Tennessee Valley Authority, 1101 Market Street, Chattanooga, Tennessee 37402

CNL-19-115

Watts Bar Nuclear Plant, Units 1 and 2  
Facility Operating License Nos. NPF-90 and NPF-96  
NRC Docket Nos. 50-390 and 50-391

Subject: **Non-Voluntary License Amendment Request to Modify Watts Bar Nuclear Plant Units 1 and 2 Technical Specifications 3.2.1, F<sub>Q</sub>(Z), to Implement Methodology from WCAP-17661, Revision 1, “Improved RAOC and CAOC FQ Surveillance Technical Specifications,” (WBN-TS-19-08)**

Figure B 3.2.1-1 (page 1 of 1)  
K(Z) - Normalized F<sub>0</sub>(Z) as a Function of Core Height

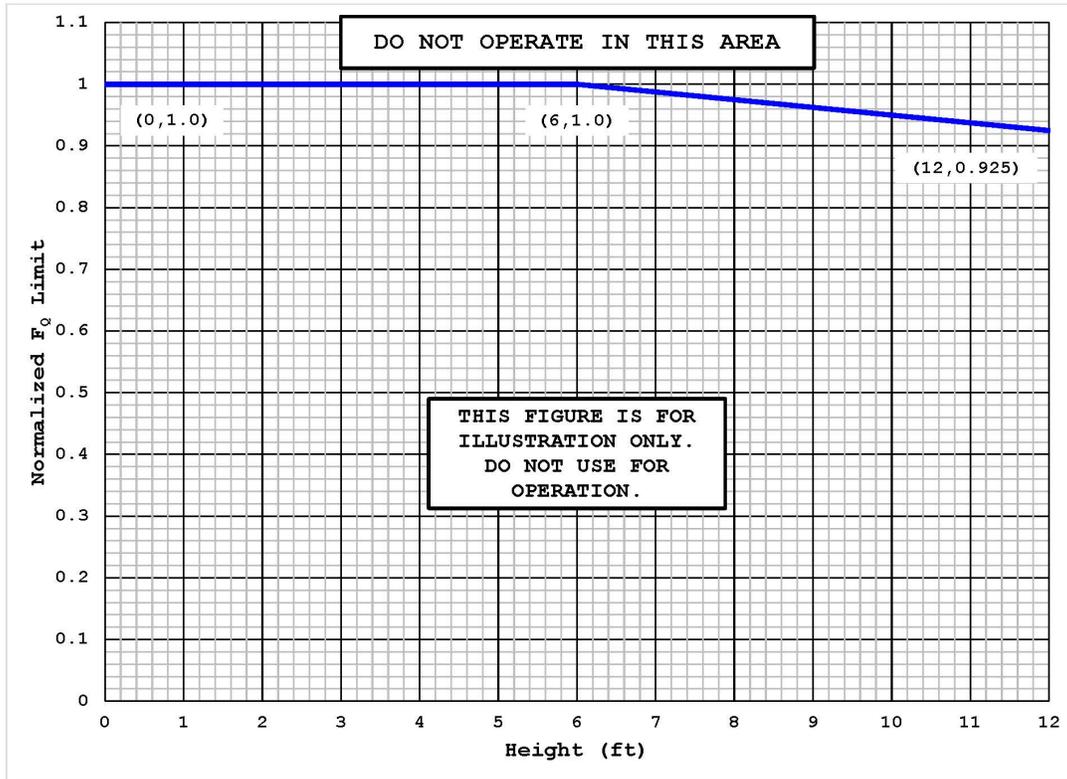
The actual values of CFQ and K(Z) are given in the COLR; however, CFQ is normally a number on the order of 2.4 2.5, and K(Z) is a function that looks like the one provided in Figure B 3.2.1-1.

Figure B 3.2.1-1 (page 1 of 1)  
K(Z) - Normalized  $F_Q(Z)$  as a Function of Core Height

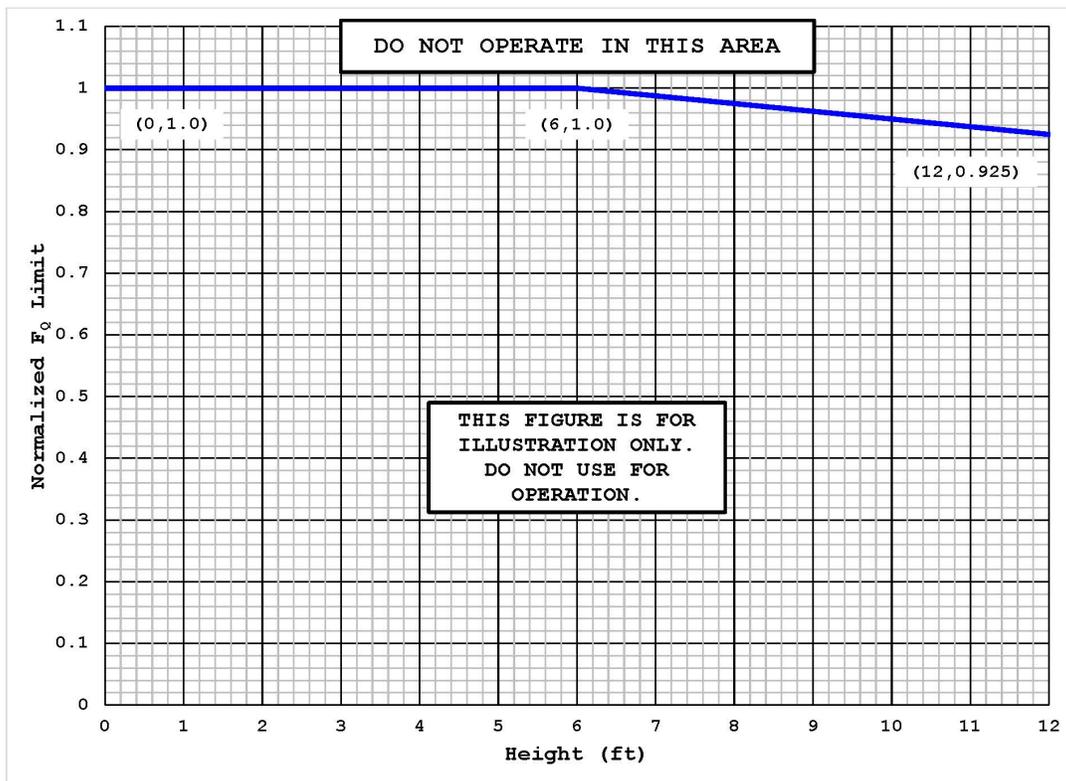
The actual values of CFQ and K(Z) are given in the COLR; however, CFQ is normally a number on the order of 2.5, and K(Z) is a function that looks like the one provided in Figure B 3.2.1-1.
